**Re: Hartwell Heights
Response to Comments**

LANDSCAPE AND LIGHTING PLAN

**Perinton Conservation Board
1350 Turk Hill Road
Fairport, NY 14450**

RE: Hartwell Heights

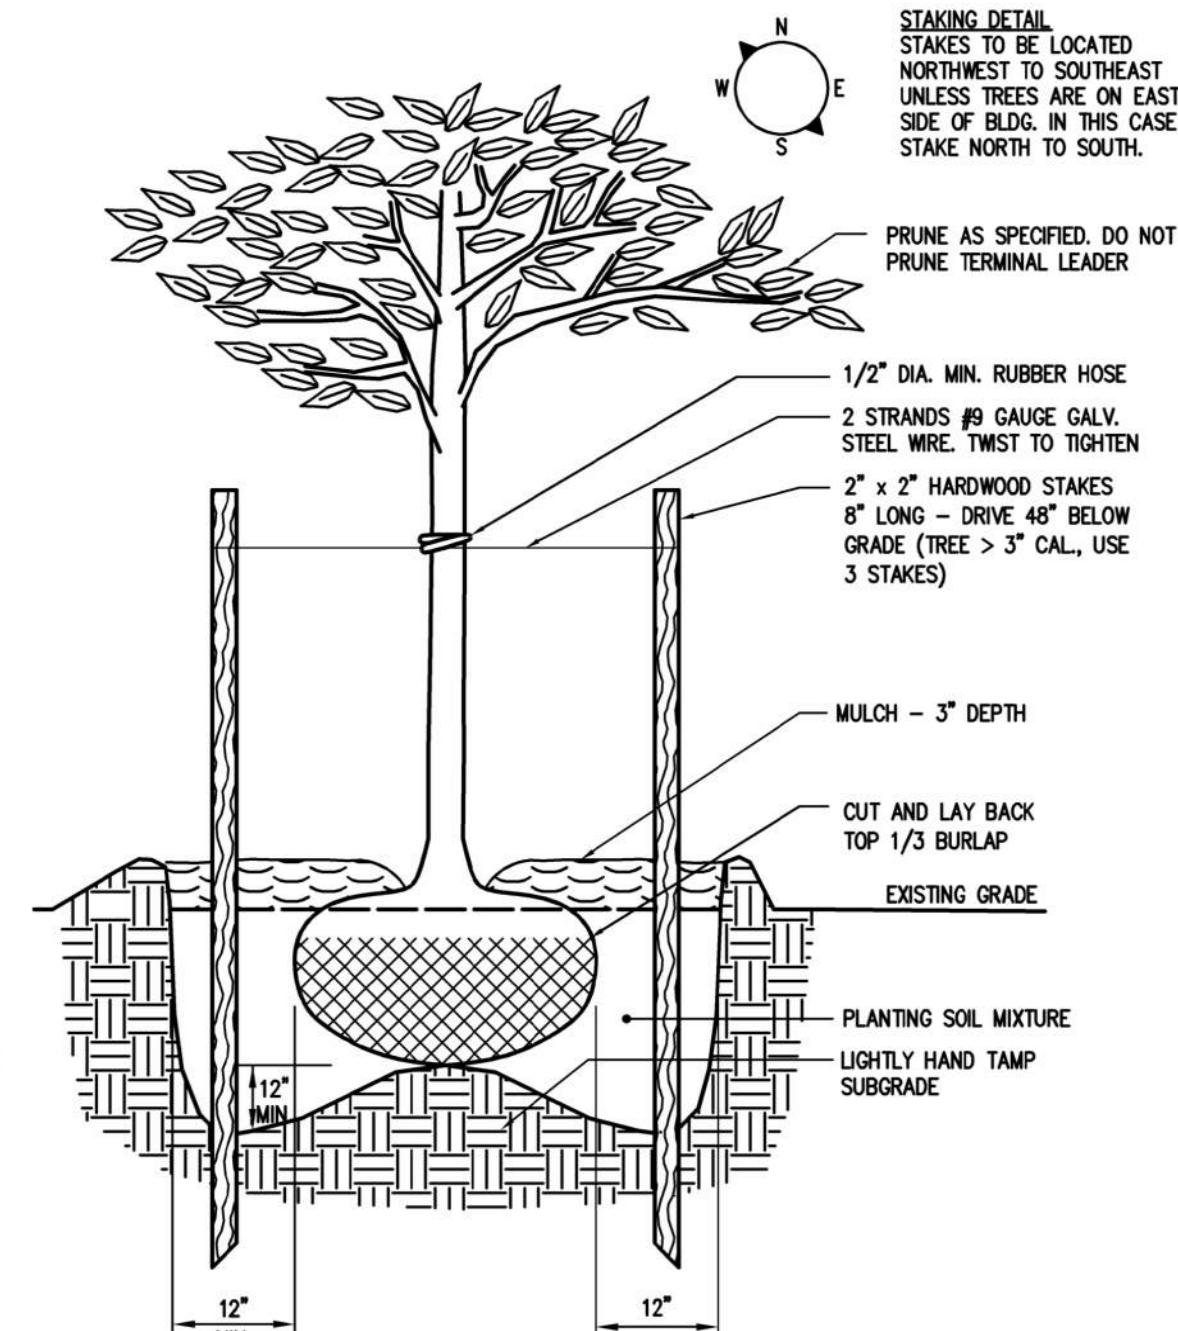
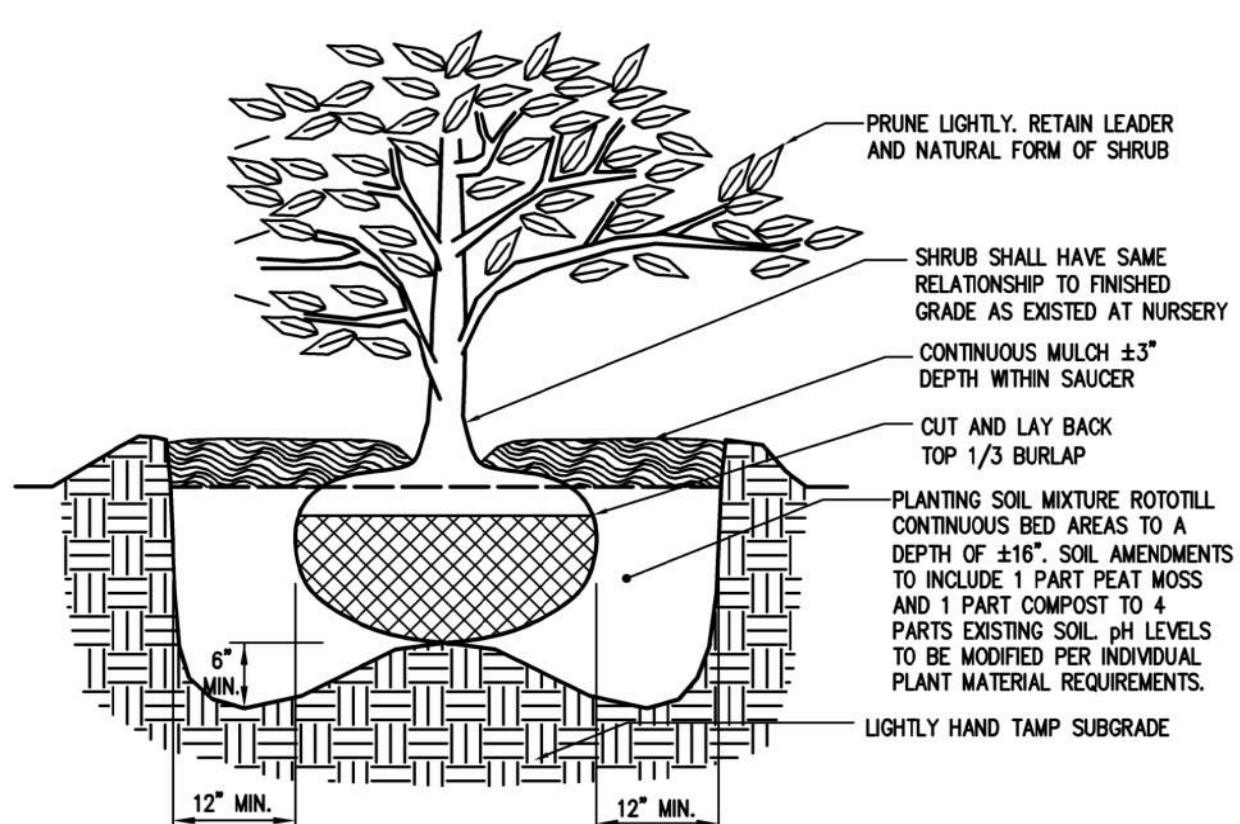
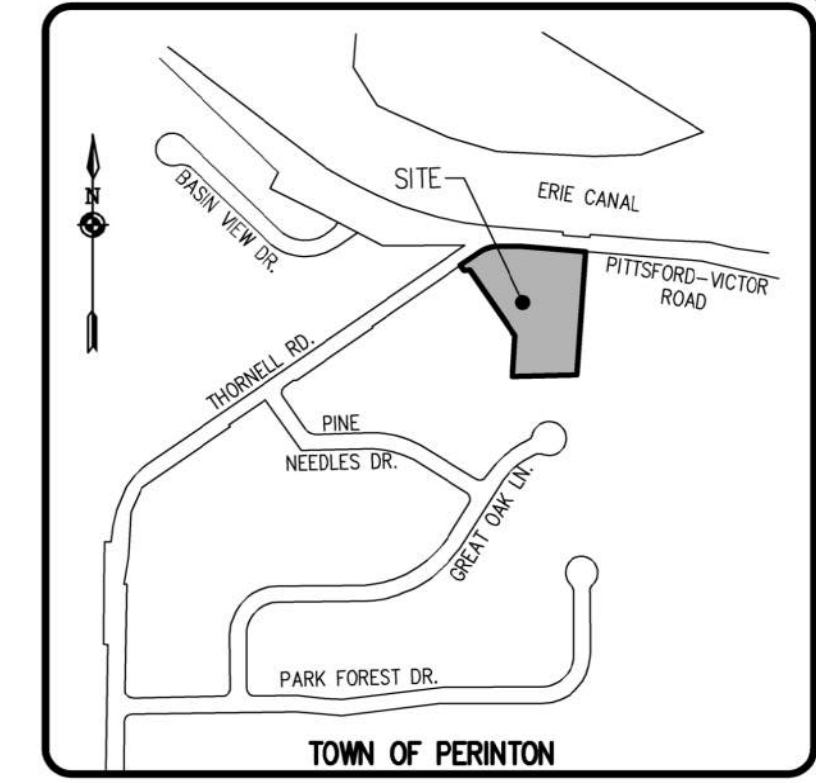
- A. Consideration of topography (undulations, berms) along site borders that could alter view impacts of proposed buildings.

- B. Identification on the plan of current mature trees that will be saved, possibly, within the area(s) of/near construction. Inclusion of these trees to lessen initial visual impacts during construction and provide aesthetic impacts following.

- C. Increased diversity in numbers and kinds of planting materials (caliber- larger & smaller mixed in and specimen type), including a more diverse evergreen type selection.

- **The original two-story, 10-unit apartment building at the southern limits of the project has been replaced with (1) single story, single-family home and (1) single story, two-unit townhome structure. It is important to note that the Mixed-Use District allows for a 40' maximum building height and two-story structures have historically existed within Bushnell's Basin (i.e Richardson's House) and on the adjacent properties to the south which include two-story single-family homes. The proposed single-story structures are also located approximately 10' lower than the existing grade at the south property line.**

- **The proposed landscape screen at the southern limits of the property consists of a mixture of various size/height evergreens and deciduous trees. The proposed trees have been placed to provide a visual buffer below the existing tree canopy. Currently there is little visual buffer at the ground level provided by the existing locust trees in this area.**

- Berms were not considered around the perimeter of the property in order to allow RG&E to service the units from the rear of the structures, as typical for a mixed-use residential development.

The (4) large existing pine trees surrounding the existing office building are proposed to be saved. Landscape Note #10 has also been added to the enclosed Landscape and Lighting Plan (BME dwg #2850-11) which states: “Owner, engineer, and contractor to use best efforts to preserve any healthy trees that are not impacted by grading, structures and utilities prior to commencing construction.” As noted above, the proposed trees buffer along the southern property limits have been placed to provide a visual buffer below the existing tree canopy. Currently there is little visual buffer at the ground level provided by the existing locust trees in this area, and the proposed plantings will infill this understory.

The mixture of evergreens has been updated to include two new species, for a total of four evergreen species now proposed. A mixture of sizes/heights of the evergreens and deciduous trees are now proposed on the enclosed updated Landscape and Lighting Plan. Three additional oak trees have been added along the east property line. Proposed utility easements limit the opportunity for additional trees/plantings in front of the cottages and 2-story buildings.
